SERVICE BULLETIN

POWER PLANT - ENGINE - INCORPORATE A REVISED RELAY BOX MOUNTING BRACKET HAVING AN
ADDITIONAL SPACER AT CP1015 - CATEGORY CODE 5 - MOD.ENG-71-0059

V2500-ENG-71-0059

Location of the Relay Box Mounting Bracket
Fig.1

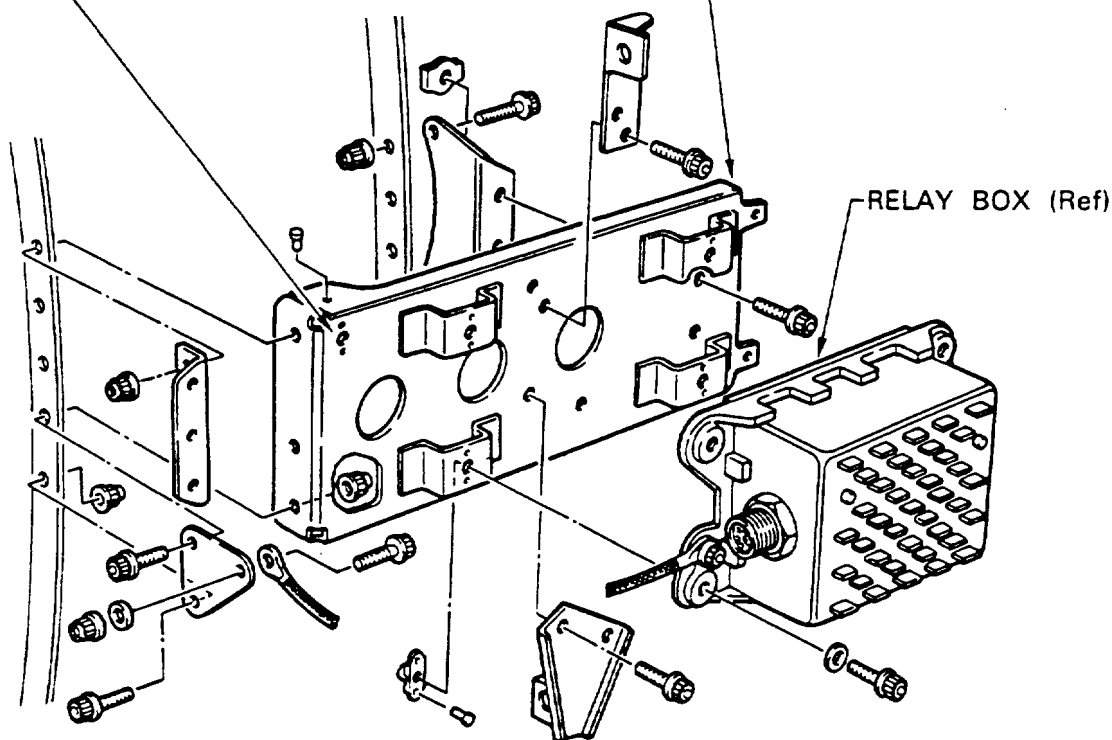
- (a) A new Relay Box Mounting Bracket which has the additional spacer at CP1015 is introduced to give an adequate clearance between the Harness and the Bracket. (See Figures 1 and 2.)
- (b) The clipping bolt at CP1015 has been changed with longer bolt in line with the additional spacer welded on the Bracket. (See Figure 2.)
- (2) The new Relay Box Mounting Bracket and the Bolt at CP1015 will be available for future replacement purposes.

6A3104 RELAY BOX MOUNTING BRACKET
REPLACE WITH NEW PN
6A4132 RELAY BOX MOUNTING BRACKET

CP1015 (See Figure 2 for Detail)

- (1) Install the new 6A4132, Relay Box Mounting Bracket, A/O, by the approved procedures in the Engine Manual, 72-00-32, Installation, TASK 72-00-32-420-002. (Refer to Figure 1 and 1.K.(2).)
- (2) At CP1015, install the new 4W0110, Bolt, in exchange for the existing 4W0104, Bolt, by the approved procedures in the Engine Manual, 72-00-32, Installation, TASK 72-00-32-420-004. (Refer to Figure 2 and 1.K.(2).)

Clipping Detail at CP1015 – Before and After Alteration
Fig.2

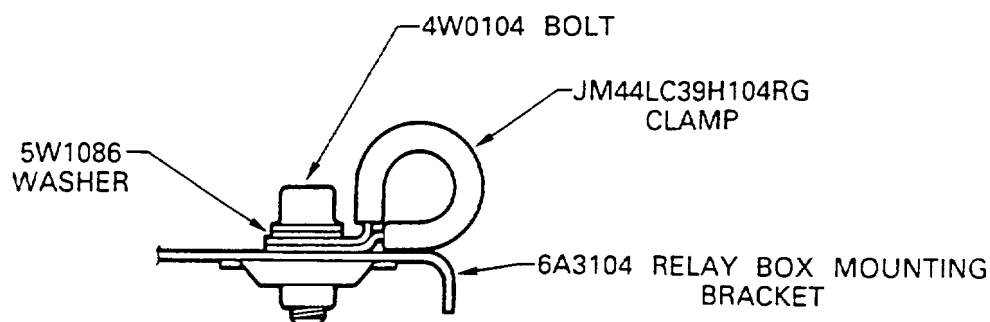
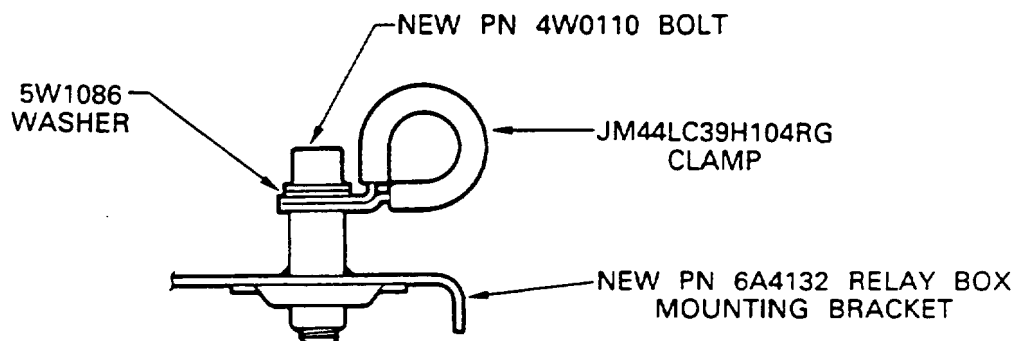
CLIPPING CONFIGURATION AT CP1015
BEFORE ALTERATION

CLIPPING CONFIGURATION AT CP1015
AFTER ALTERATION
